Access Compliance Report Public Rights-of-Way (RR Crossings)

Intersection ID: 10034711	Main Street: POINDEXTER_DR	Location:	N/A
ADA ID: 31179F946E83	Overall Compliance: No	Severity Score:	0.0
Codes/Mitigation Info/Possible Solution		Field Measurements/Component Compliance

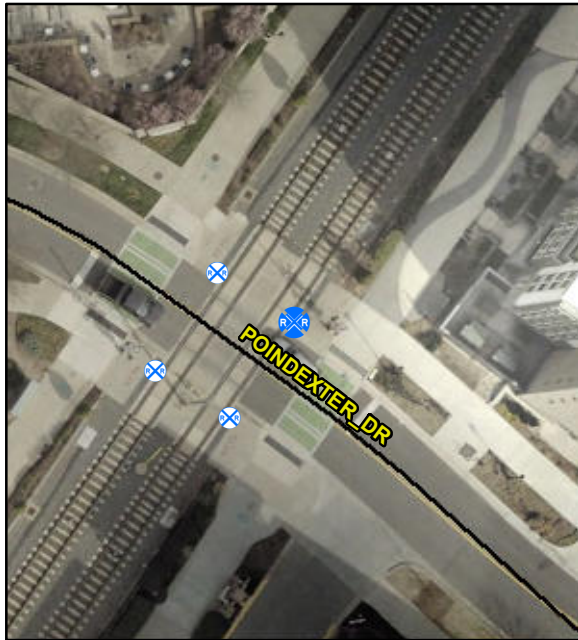
**Remove & Replace Detectable
Warning System. Provide Pedestrian
Gate. Remove & Replace Walking
Surface Adjacent to Rail.**

R302.7.4, R305.2.5

Compliance	Description	Data
Yes	DWS Provided?	Yes
Yes	DWS Contrast?	Yes
Yes	DWS Width (in)	Yes
Yes	DWS Length (in)	24.0
No	DWS Offset (in)	11.0
No	Pedestrian Gate?	No
N/A	DWS Outside Gate?	N/A
N/A	Rail Type?	LightRail
No	Flangeway Gap (in)	3.0
Yes	Sidewalk Width (in)	117.0
